**Town of Kittery  
 Planning Board Meeting  
 January 12, 2023**

**ITEM 3 – 41 Route 236 – Preliminary Site Plan Review**

**RE: Preliminary Site Plan Review – Request for Continuance  
Well Field 44 Cannabis Dispensary (Tax Map 29, Lot 1)  
41 Route 236, Kittery, Maine**

STORMWATER: EXPANDED DEVELOPED CONDITIONS  
WELL FIELD 44 CANNABIS DISPENSARY  
41 ROUTE 236, KITTERY, ME 03904

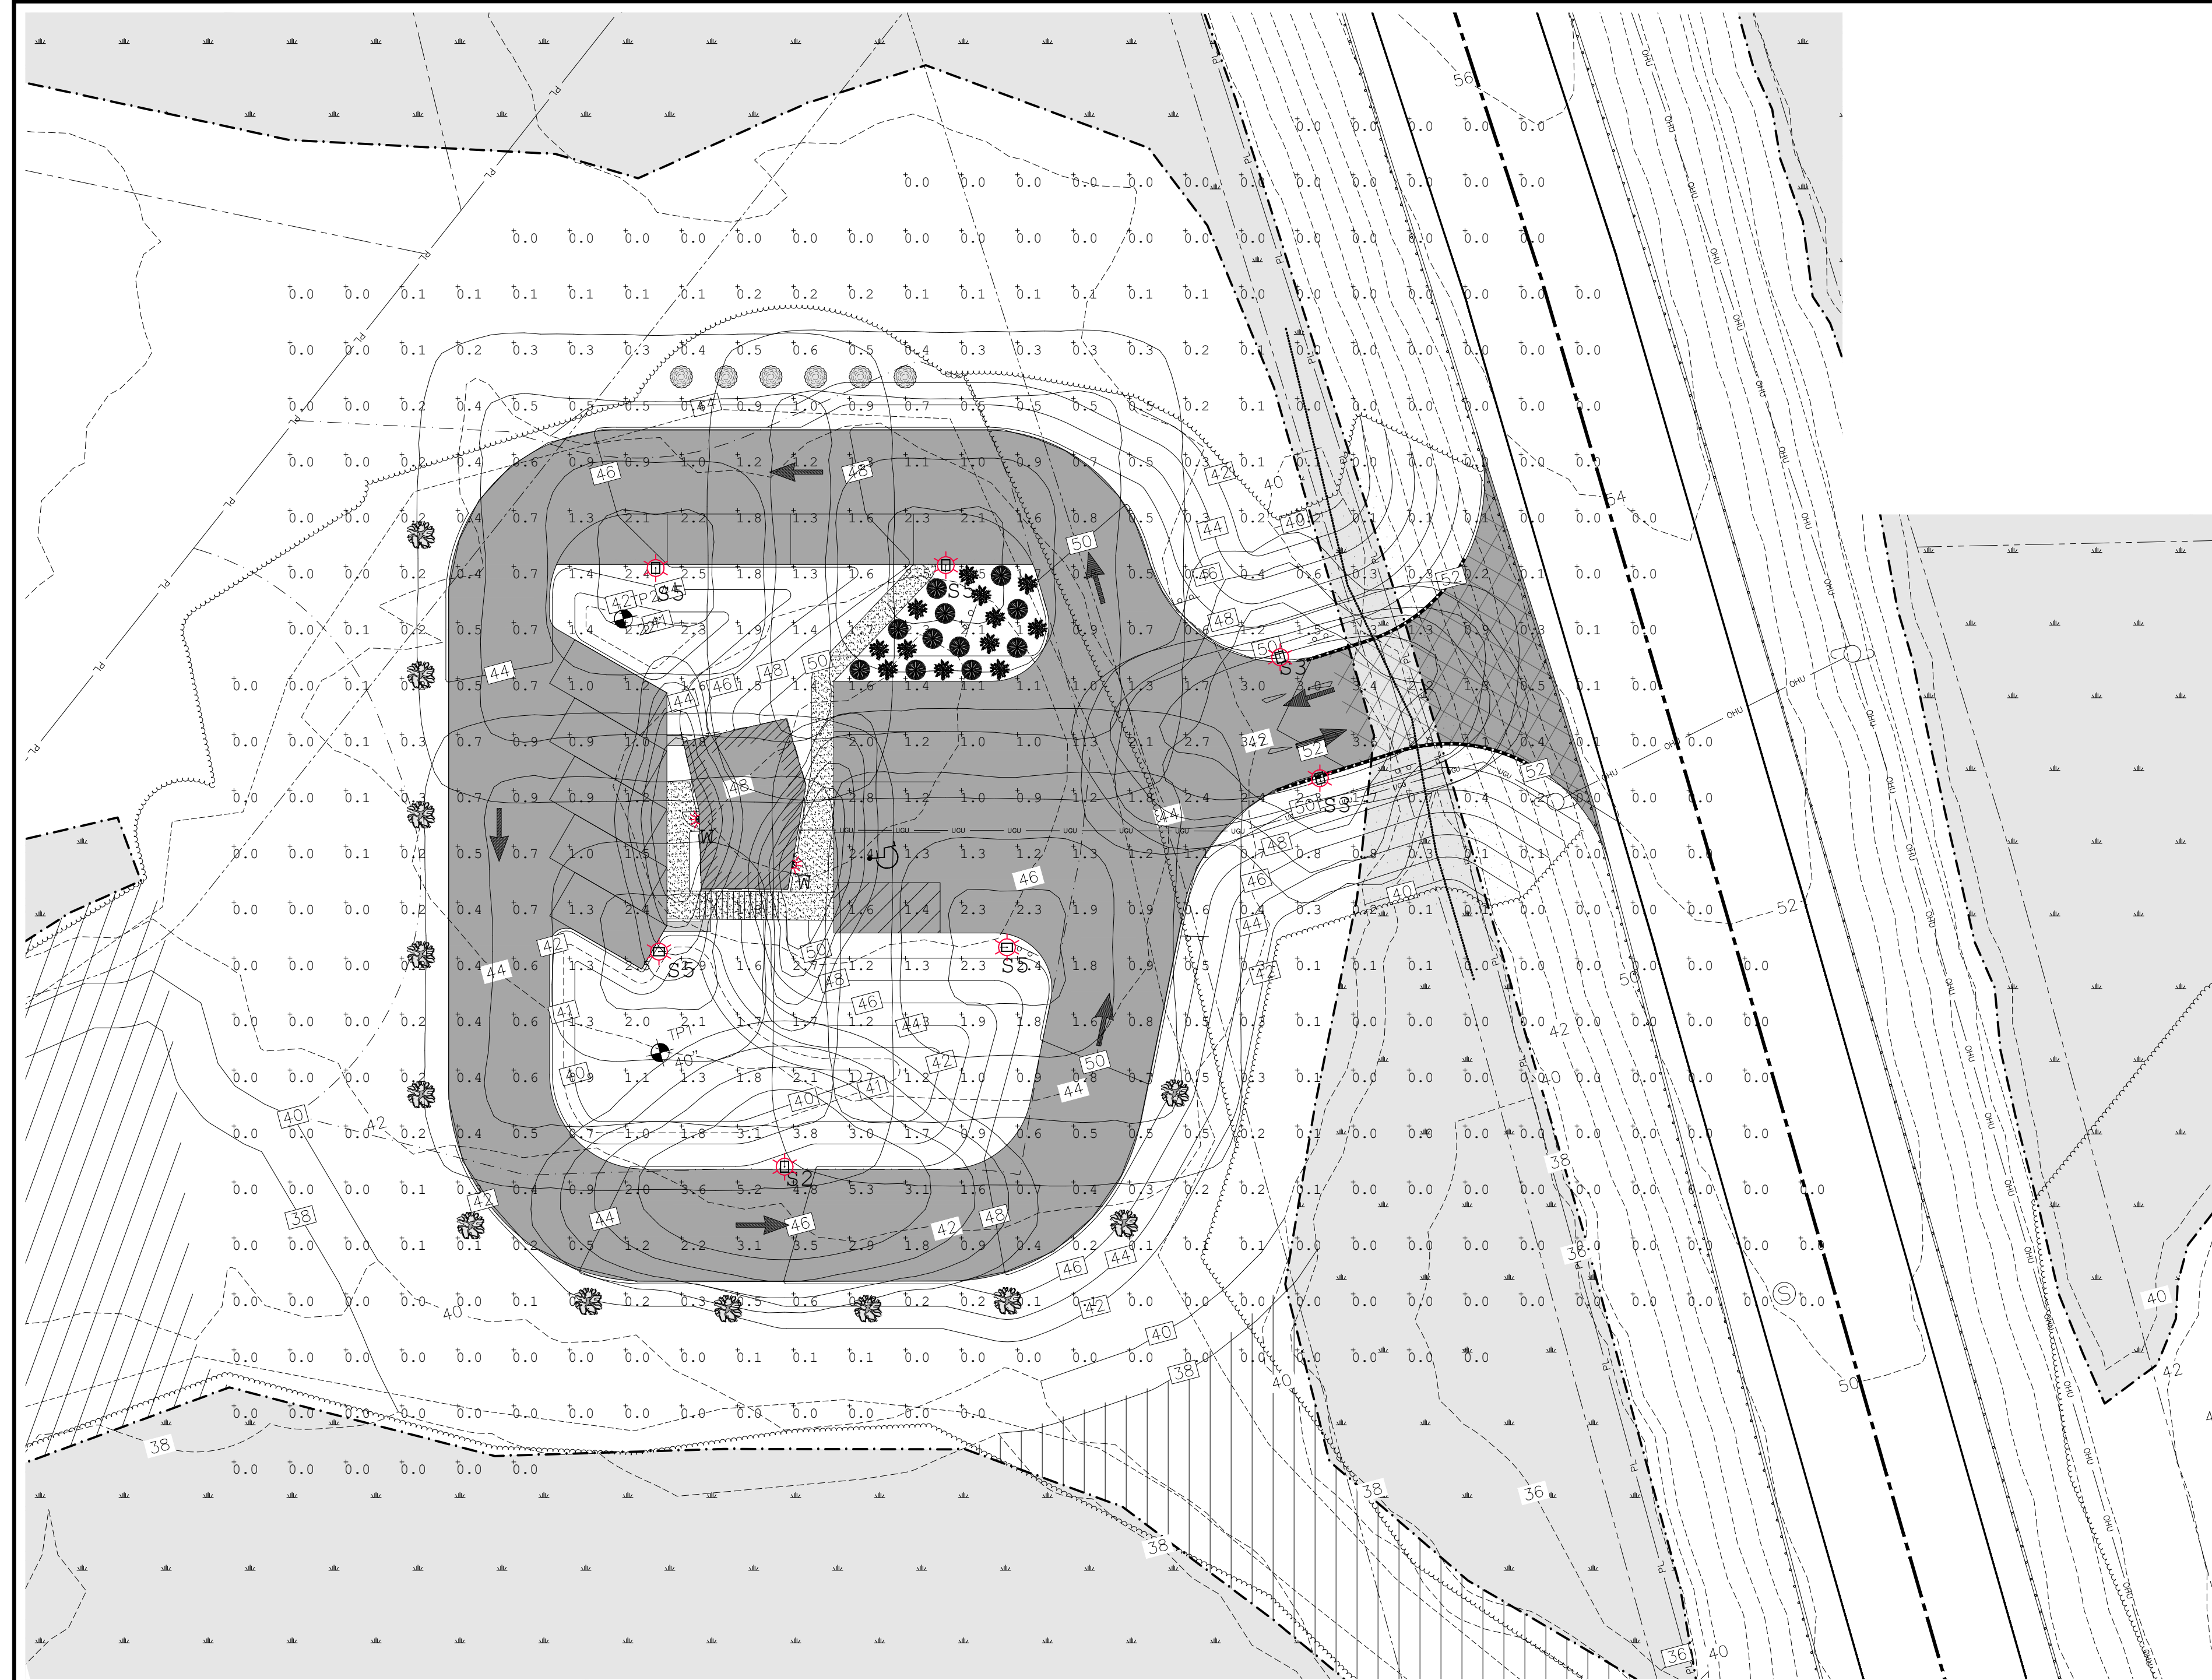
- Sheet 8 has been updated to include a callout identifying the inverts, size, and pipe material of the downstream culverted crossing of Dana Avenue. This street was incorrectly labeled as Manson Road in a previous iteration of the Plan Set, and has now been changed.

JOB NO: C277-21 FILE: WF44 DEV BASE.DWG SHEET: 9

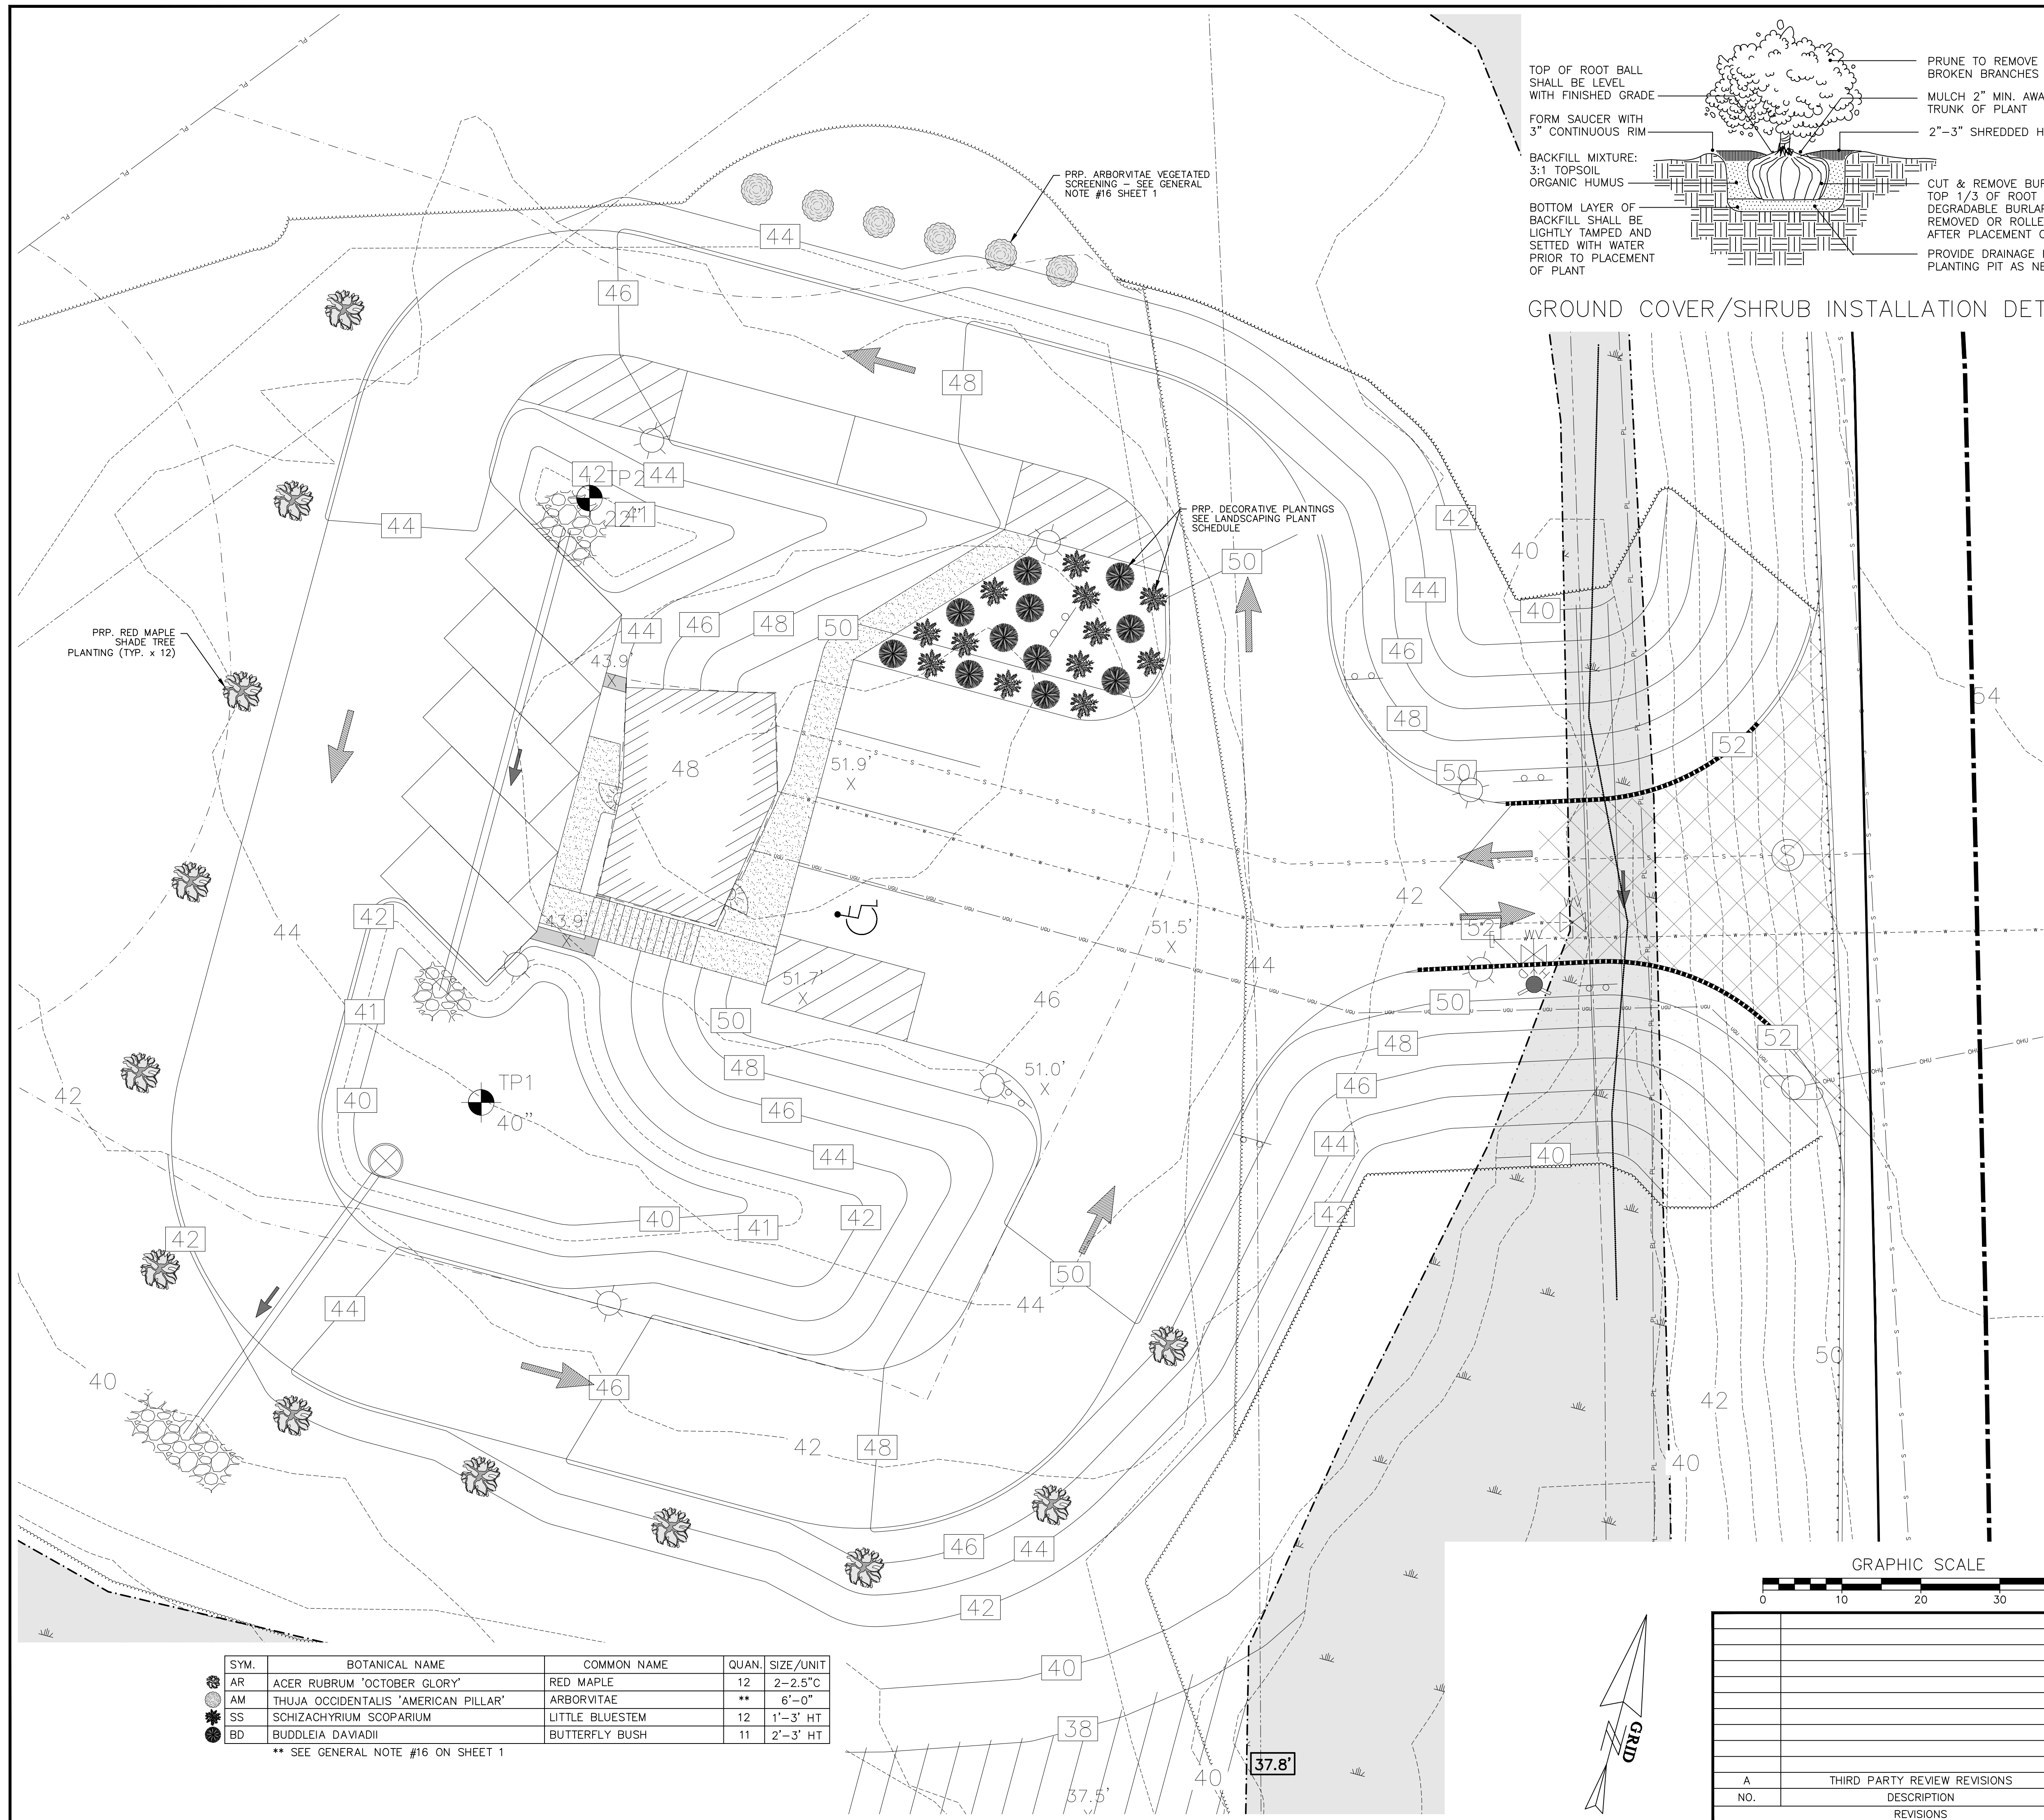
- The Photometric Plan (Sheet 9) has been updated to provide increased clarity on the pole locations and the light that they shed around the proposed development. Specification sheets have also been provided on this page for the selected fixtures proposed around the site.

- A "Lighting Requirements" notes package has been added to Sheet 9, which details the uniformity ratios outlined in Kittery Town Code §16.7.11.H and demonstrates compliance with the illumination requirements for the entrance and parking aisles of the proposed development.

- The Photometric Plan (Sheet 9) has been updated to include the uniformity ratios for relevant illumination requirements of this development as discussed above in the “§16.7.11 Performance Standards and Approval Criteria” section.
